INDESIT company

RA27IXFR

F028853

Notices

N1025118FIG1

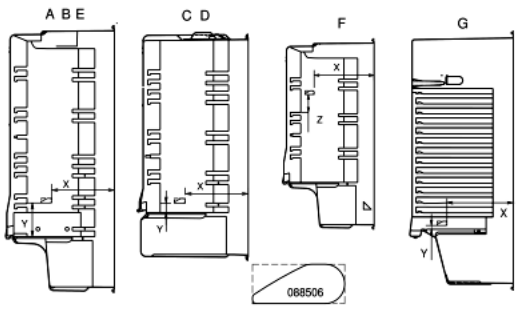
n1025118: French products temperature indicator

Since April 2002 (serial no. 20404.0001) the Melano, Carinaro and Setubal factories have been fitting the temperature indicator "for better and precise identification of the coldest area inside the refrigerator compartment", on free-standing products intended for the French market.
The temperature indicator, code 088506, consists of a zamak casing fitted with a temperature-sensitive liquid crystal disk. (see see NT008400). On the back of the zamak casing there is a biadhesive for sticking it to the refrigerator cabinet, after carefully cleaning the application area with a heptane-based degreasing product (or similar suitable product).

"OK" must appear on the indicator (correct lighting will enable better reading of the indicator).
If the indicator appears completely black, this means that the average temperature of the area is too high (higher than +4°C). In this case the temperature must be decreased (colder) by operating the device that controls temperature inside the refrigerator. With each change, wait for the temperature inside the refrigerator compartment to stabilize (approx. 10hr) before doing another adjustment.

In models with chiller, as this area has coldest temperature in the entire fridge compartment,
"the temperature indicator" is located inside in order to be able to check the correct value.

In models without chiller, the position of the temperature indicator varies according to the type of product: double-door and single-door fridge, combination fridge-freezer, etc.

Below is a summary table giving the values for correct positioning:

1.Value (X) indicates the distance from the rear wall
2.Value (Y) indicates the distance from the top of the crisper lid
3.Value (Z) refers to the top of the glass shelf on the third guide from the top.

n1025157: New central hinge for Indesit-55 2-door 240 litre refrigerators (Carinaro)

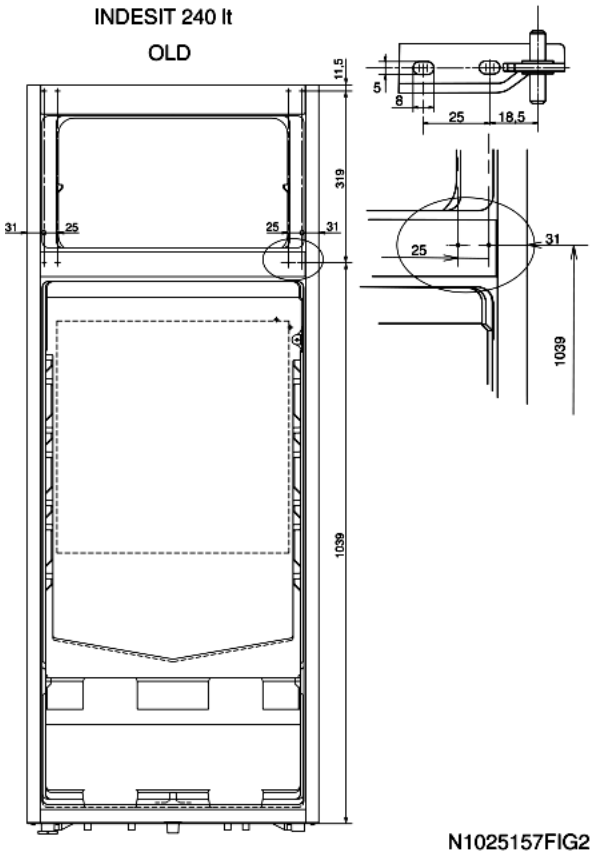
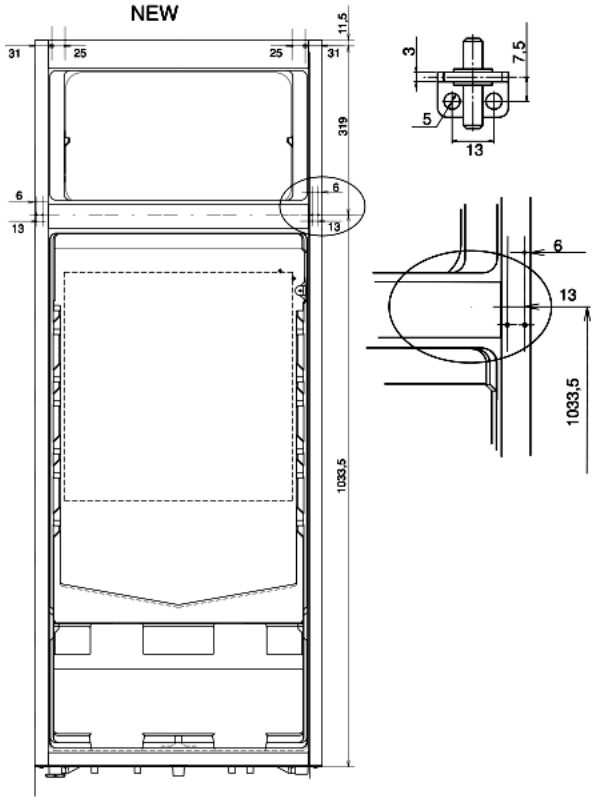
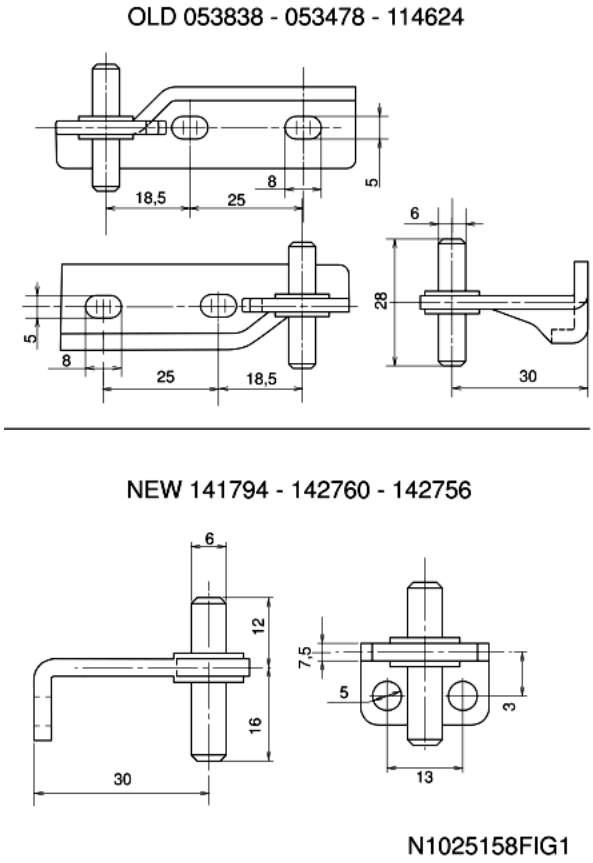
From serial no. 60123.0001 the Carinaro factory has modified the body of the 240 litre refrigerator by introducing a new central

hinge (see figure N1025058 Fig.1) secured to the side panel. In addition, the height of the refrigerator door has been reduced from 1030 to 1028 mm.
This hinge is still reversible but it cannot be fitted on premodification models, on which the hinge was attached to the central trim of the refrigerator cabinet (see figure N1025157fig2).
When changing the door opening from right to left, the new hinge does not need to be inverted like the previous one, just moved to the left side.
To fix the hinge drill a hole on the left side of the refrigerator cabinet (see figure N1025157fig3).

NB - 1028 mm high doors can be fitted to premodification models by using a 2 mm washer (028928 - 034618 - 036775) on the lower hinge.

141794 - POLAR WHITE CENTRAL HINGE (CARINARO)
142756 - CHROME-PLATED CENTRAL HINGE
143328 - REFRIGERATOR DOOR ROUNDED-STYLE/TEAK 540X1028X55 GIUGIARO
143327 - REFRIGERATOR DOOR ROUNDED-STYLE/SILVER 540X1028X55 GIUGIARO
143326 - REFRIGERATOR DOOR ROUNDED-STYLE/S.STEEL 540X1028X55 GIUGIARO
143325 - REFRIGERATOR DOOR ROUNDED PW 540X1028X55 GIUGIARO

053838 - CHROME-PLATED CENTRAL HINGE
053478 - WHITE CENTRAL HINGE
114624 - POLAR WHITE CENTRAL HINGE
084826 - REFRIGERATOR DOOR ROUNDED-STYLE/TEAK 540X1030X55 GIUGIARO
083820 - REFRIGERATOR DOOR ROUNDED-STYLE/SILVER 540X1030X55 GIUGIARO
094790 - REFRIGERATOR DOOR ROUNDED-STYLE/S.STEEL 540X1030X55 GIUGIARO
141581 - REFRIGERATOR DOOR ROUNDED-STYLE/PW 540X1030X55 GIUGIARO

n1025158: New central hinge for Ariston-55 2-door 240 litre refrigerators (Carinaro).

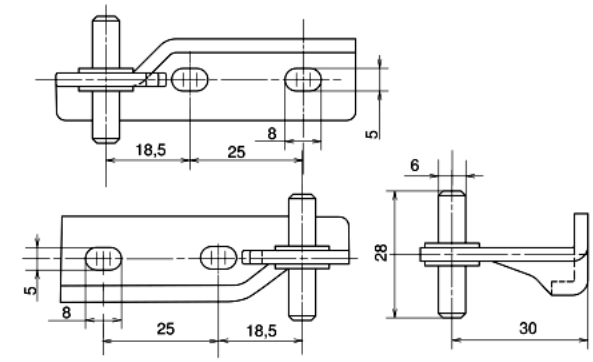
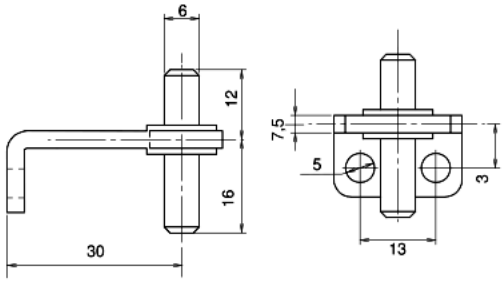
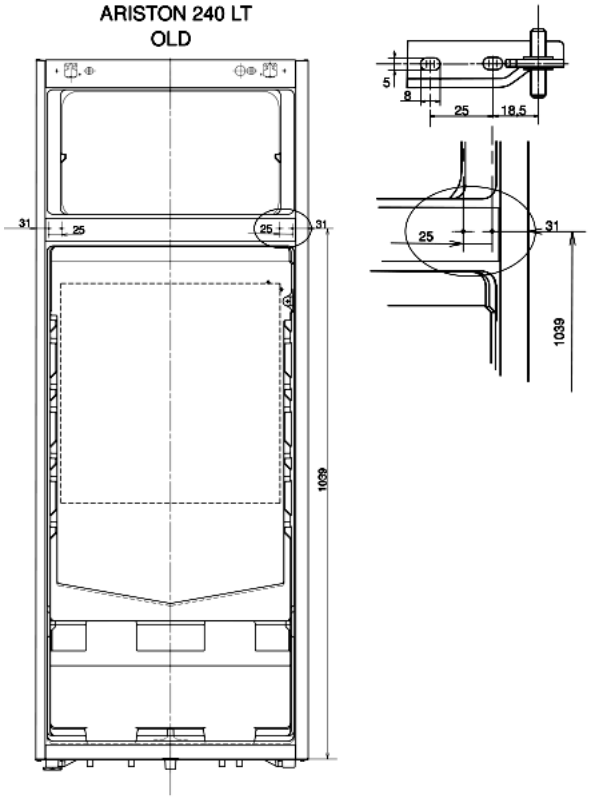
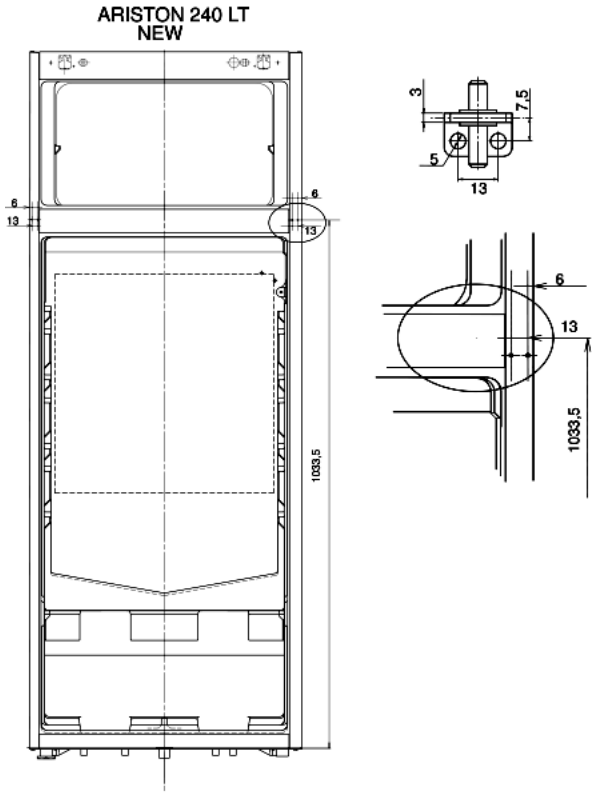
From serial no. 60123.0001, the Carinaro factory has modified the body of 240 litre refrigerators by introducing a new central hinge (see figure N1025058 Fig.1) attached to the side panel.
This hinge is still reversible but cannot be fitted on premodification models where the hinge was attached to the central trim of the refrigerator body (see Figure N1025058fig2).
When changing the door opening from right to left, the new hinge does not need to be inverted like the previous one, just moved to the left side.
To secure it, a hole must be made on the left side of the refrigerator body (see figure N1025058fig3).

141794 - POLAR WHITE CENTRAL HINGE (CARINARO)
142756 - POLAR WHITE CENTRAL HINGE (MANISA)
142756 - CHROME-PLATED CENTRAL HINGE

053838 - CHROME-PLATED CENTRAL HINGE
053478 - WHITE CENTRAL HINGE
114624 - POLAR WHITE CENTRAL HINGE

OLD 053838 - 053478 - 114624

NEW 141794 - 142760 - 142756
